**Exhibit 6 – December 23, 2022, APE Letter to the HI SHPD and
Response**

Re: Continuing Consultation under Section 106 of the National Historic Preservation Act for the development of an Air Tour Management Plan for Hawai'i Volcanoes National Park (HICRIS Project 2022PR00353)

**SUBJECT: National Historic Preservation Act (NHPA) Section 106 Review –
Continued Consultation and Request for Comments on the Area of Potential Effects
Air Tour Management Plan for Hawai'i Volcanoes National Park
Humu'ula, Kahue, Kealakomo, Lac'apuki, Pānaui-iki, 'Āpua, Poupou 1-2, Pūlama,
Pānauinui, Kamoamo, Kahauale'a, Kaulanamauna, Kapu'a, Anapuka, Ho'opūloa, Pāpā 1,
Pāpā 2, 'Alikā, Kīpahoe, Ka'apuna, 'Ola'a, Kea'au, Kī'ao, Kamā'oa, Pu'u'eo, Ke,
Pākiniki, Pākininui, Pu'ulena, Waiomao, Kiolaka'a, Pu'umaka'a, Manukā, Wai'ōhinu,
Ka'alāiki, Hi'ona'a, Pā'au'au 1, Palima, Halelua, Wailoa, Kumu, Kea'wa, Pā'au'au 2,
Ka'ala'ala, Kanaio, Wailau, Nīnole, Ka'a, Kahuku, Kapāpala, Keauhou, Ka'ohe Mauka,
Kī'ilae, Keālia 1, and Keauhou 2 Ahupua'a
Hilo, Puna, Kona, Ka'ū, and Hāmākua Districts, Island of Hawai'i
TMK: (3) 1-9-001:007**

Area of Potential Effects at Hawai'i Volcanoes National Park

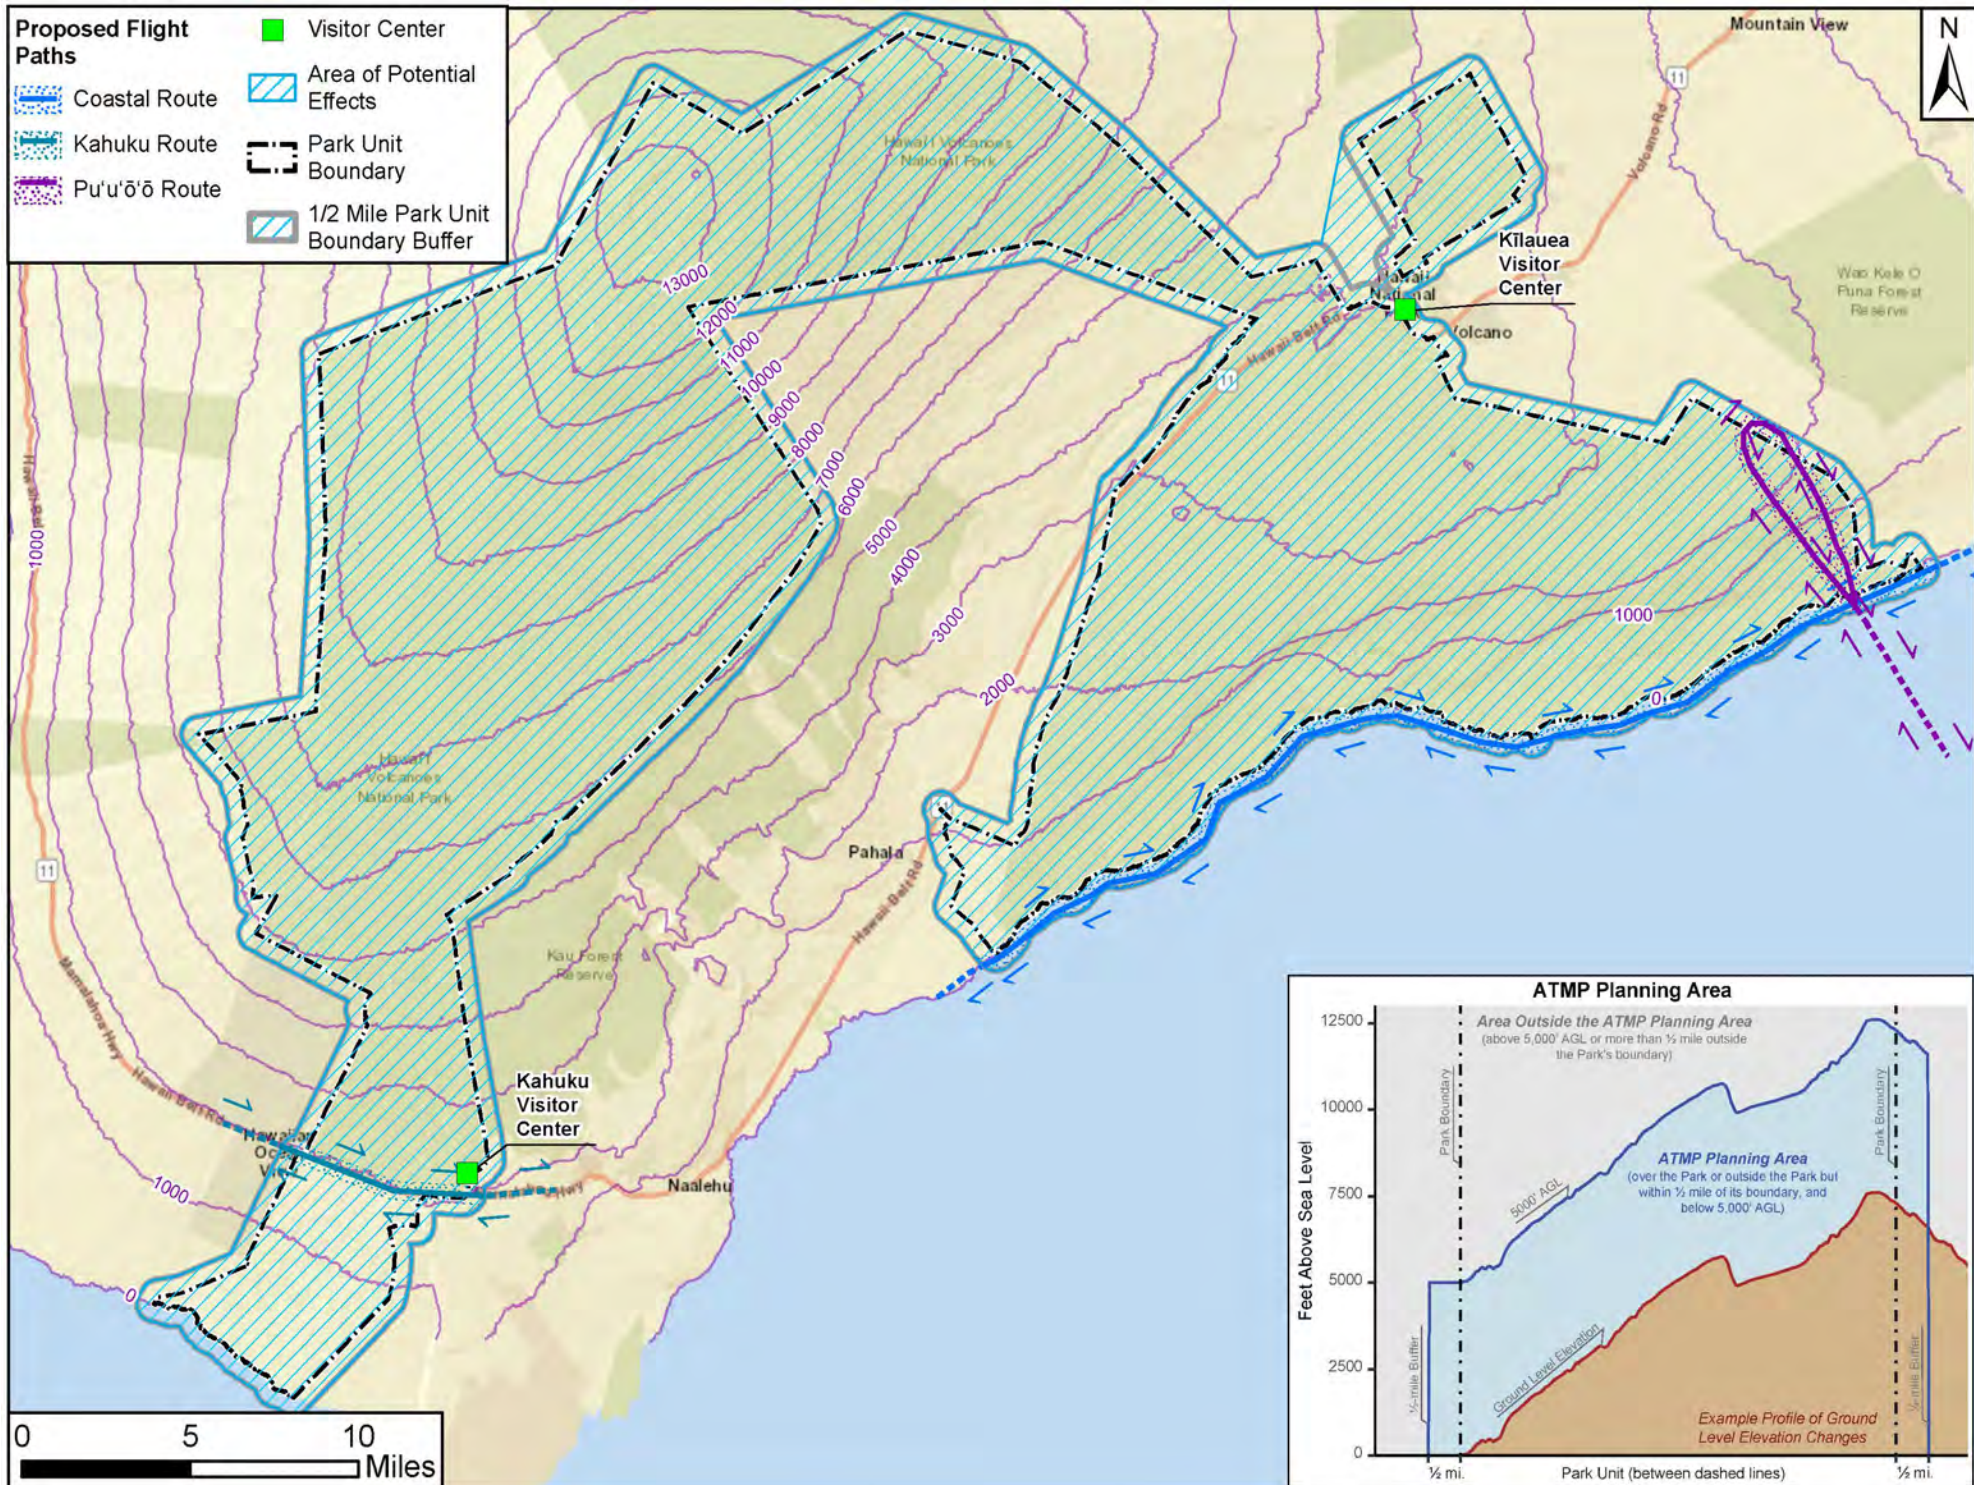
In response, the SHPD offers the following for consideration. Consulting party comments during recent consultation for this project raised concern with how the audio and visual effects from commercial air tours may affect Hawaiian practices. Therefore, it is important for an undertaking such as this, that the agency also take into consideration intangible resources, more specifically traditional cultural properties, which may not yet have been identified and which could be affected by the proposed undertaking.

The FAA proposes an APE comprising the HAVO Park, areas outside the park but within ½ mile of its boundary, and a small area to the southwest of the 'Ōla'a Forest tract between it and the main Park. The APE extends vertically from ground level to above 5,000 feet.

Based on the information received, SHPO has no objections to the APE at this time. However, the SHPO looks forward to receiving documentation of comments received from consulting parties regarding the APE, and the FAA and NPS's response to comments.
